SSI Rapport 2008:05

SKI Rapport 2008:15

International Expert Review of Sr-Can: Safety Assessment Methodology

*External review contribution in support of
SSI's and SKI's review of SR-Can*

Figure 1. Dose from releases to geosphere for different canister thicknesses. 1,000 realizations of each case, analytical model.

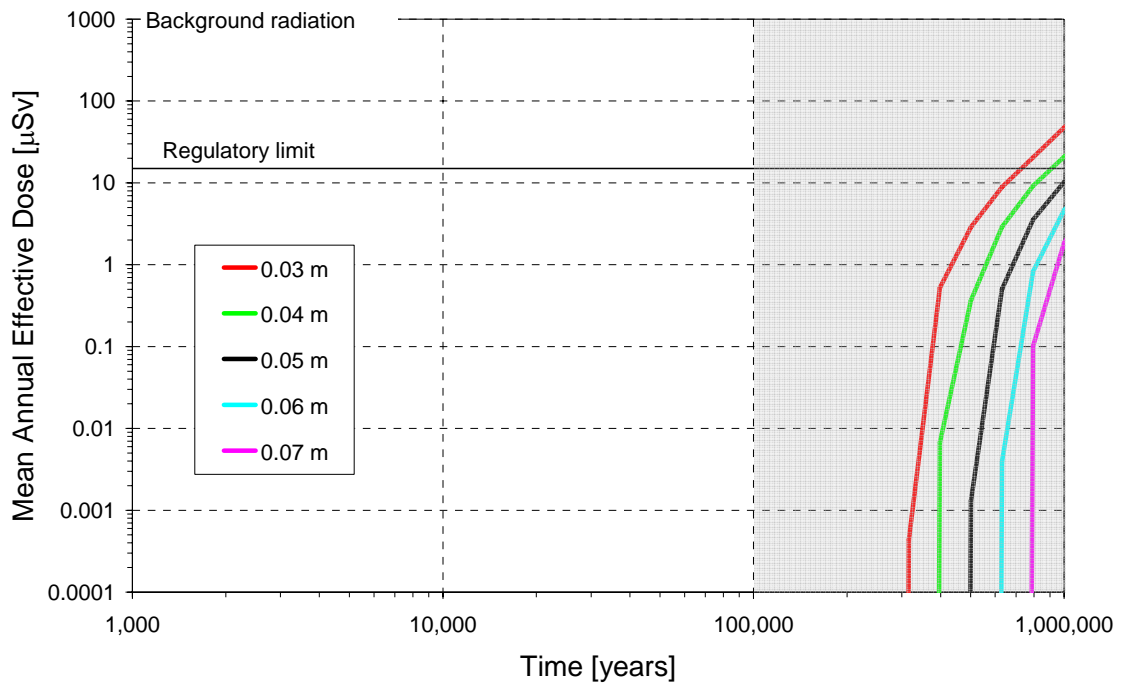
59.	<p>Has SKB carried out any simple sensitivity analyses for the Safety Functions? Those presented in Section 10 do not address the safety functions directly, or at least are hard to interpret. Consequently, Section 13 contains many unsupported assertions that would be easier to judge if there were diagrams showing, for example, sensitivity of calculated risk to canister thickness, buffer function longevity, number of canisters failed, etc. Can SKB show any information of this type?</p> <p>Sensitivity to canister thickness was not calculated in SR-Can, but can readily be done using the expressions in Appendix B to the main report. This has now been carried out and the result is shown in Figure 1 below. The figure shows the effect of varying the canister thickness around the reference value of 0.05 m for the Forsmark advection base</p>

case (Figure 10-42 in the main report). The risk contribution from the advection/corrosion scenario (not calculated here) is expected to vary in a similar manner. Note that no other consequences of an altered canister thickness (possibility of handling the canister at all stages prior to deposition, defect distribution when welding a different thickness, etc) have been looked into.

Sensitivity to buffer longevity has been bracketed by the three cases considered: Immediate loss of buffer, buffer loss according to the crude Qeq-model and no buffer loss. As discussed in chapter 13 and elsewhere, the two former assumptions yield almost identical results, whereas the third implies that the risk contribution from the advection/corrosion scenario vanishes.

Figure 2. SRRC results for rock transmission at Forsmark.

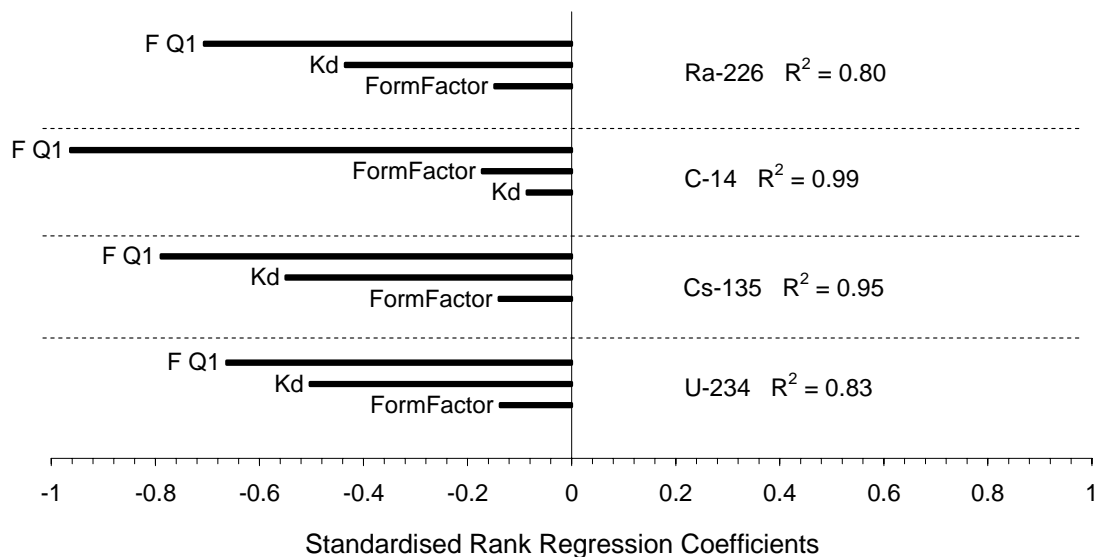
In any case, it would be helpful to receive a more elaborate explanation of the results presented in 10.5.9 and of the lessons that can be learned from them.

These sensitivity analyses were left out due to time constraints and since they are not expected to provide appreciable new information in relation to the Interim report. (No, the quoted sentence is not an obsolete relict from the Interim report, but it should really read “discussed in section 10.5.10” rather than “used in section 10.5.4”. The text referred to was originally part of section 10.5.4 and then moved to 10.5.10. Unfortunately, the reference was not updated.) Some SRRC-analyses have now been done and the ones for the transmission calculations for Forsmark are given in Figure 2 below. The results are quite similar to those in the Interim report in that uncertainty/variability of the F-factor of the rock has the highest influence on output uncertainty, followed by the Kd-value of the nuclide in question or the Formation factor (which expresses the uncertainty/variability of the effective diffusivity in the rock, see table 10-3 of the Main report and further the Data report, section 6.7). Further SRRC-results are given in the answer to OVERSITE question 4.

Lessons learned from the results in section 10.5.9: The Figures in section 10.5.9 show the distribution of geosphere transmissions over the ensemble of deposition holes at the two sites. The Figures demonstrate that a considerable fraction of the deposition holes (around 62% and 52% for Forsmark and Laxemar, respectively) are either not intersected by the fracture network, or intersected by fractures associated with such transport conditions that a release through this fracture never reaches the surface. (This is evident already from the hydrogeological analyses in section 9.3.6.)
